ADVISORY REPORT
FINDINGS, CONCLUSIONS, AND RECOMMENDATIONS

Date: June 22, 2011

File: **ZON11-00003 - A.G. BELL ELEMENTARY SCHOOL MASTER PLAN & PLANNED UNIT DEVELOPMENT (PUD)**

L1.0
SHEET

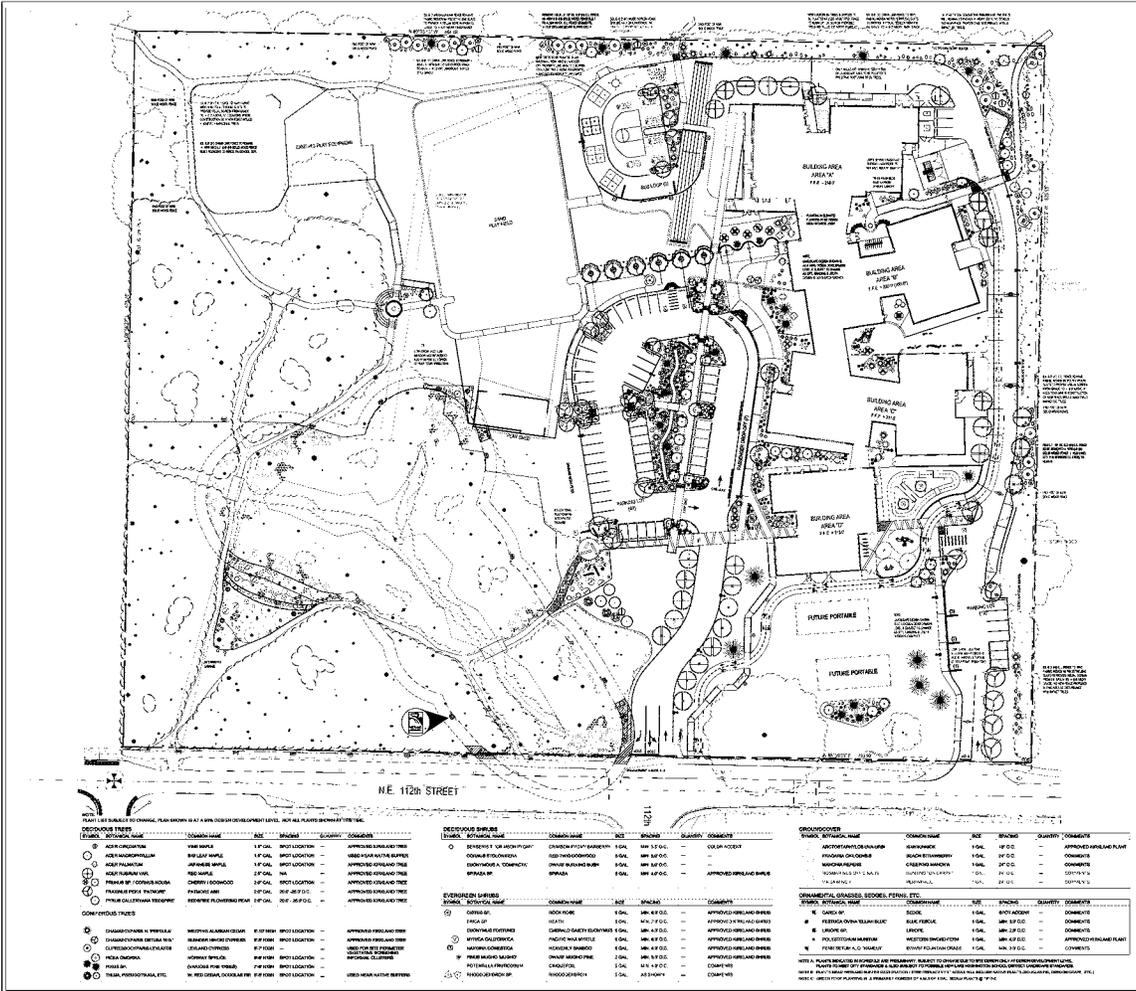
5. Building and grading permit plans shall be consistent with the proposed parking and student drop-off/pickup configuration shown in Attachment 2, Sheet L1.0. In addition, the school is required to do the following (see Conclusion II.G.2.b):

- i. The subject property is located within the Forbes Creek Drainage Basin which has been classified by the City as a primary basin. A Type 3 wetland is located in the southwest portion of the subject property (see Attachment 2, Sheet L1.0). A Type 3 wetland within a primary basin requires a 50-foot buffer. Pursuant to KZC Section 90.45.5, minor improvements such as trails are allowed within the outer one-half of the wetland buffer. Pedestrian bridges may be placed where approved crossings are allowed.

- iv. Attachment 2, Sheet L1.0 contains a site plan which shows modulated building facades within 100’ of the north and east property line. The buildings are modulated as follows:

- (c) Large mature trees line the north property line, some of which are deciduous trees (see Attachment 2, Sheet L1.0, Attachment 5, and Attachment 13). Even with a six-foot tall wooden fence installed at the north property line, there are potential visual gaps between the bottom of the tree canopy and the top of the wooden fence. Consequently, there is a potential for visual and noise impacts from the buses to adjoining properties to the north.
